**STAFF REPORT  
FOR THE HISTORIC REVIEW BOARD**

**FILE NUMBER:** DR-20-04

**REQUEST:** Class II Historic Design Review – The proposal is to replace 13 windows and siding on the south elevation of the church at 1683 Willamette Falls Drive.

# WILLAMETTE UNITED METHODIST CHURCH FACADE UPGRADES

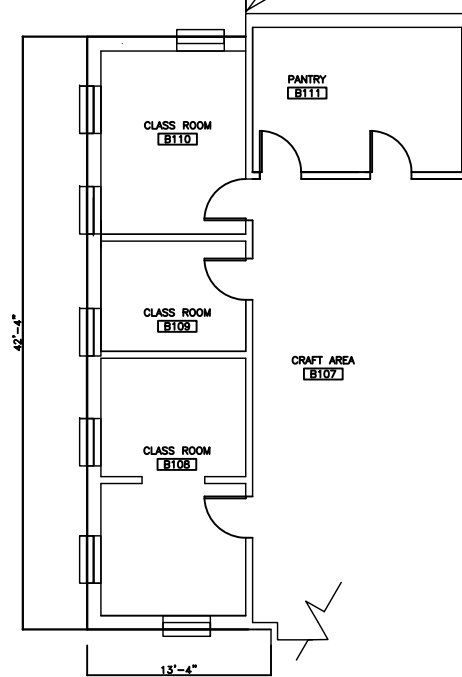
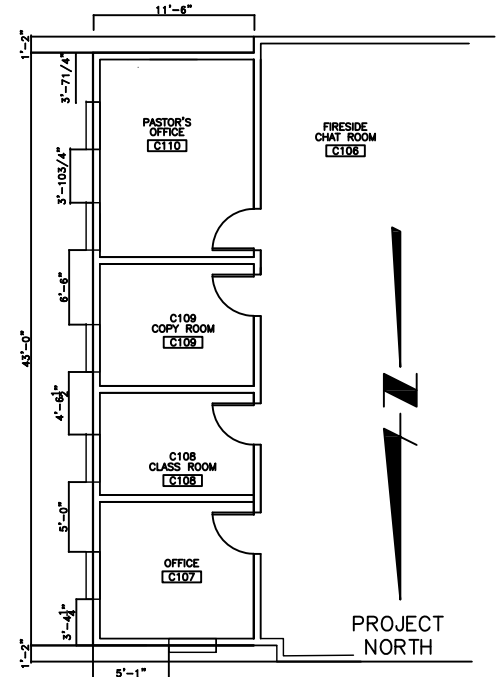
**Staff Finding 9: The applicant has proposed replacing existing wood siding with new composite siding. The applicant has provided photographs of the existing and replacement siding to demonstrate being in character with the texture and finish of the original material. Subject to Historic Review Board approval of the replacement materials, the criteria are met.**

**Staff Finding 22: The applicant is proposing to replace 13 double-hung wood windows (six-over-one lights on second story, one-over-one lights on first story) with one-over-one vinyl-clad wood single-hung windows. The replacement windows will maintain the existing height to width ration. The criteria are met.**

**Staff recommends approval of the application to replace windows and siding on the south side of the addition, subject to the Historic Review Board’s approval of the type and design of materials to be used. Subject to approval, the following conditions should be adopted:**
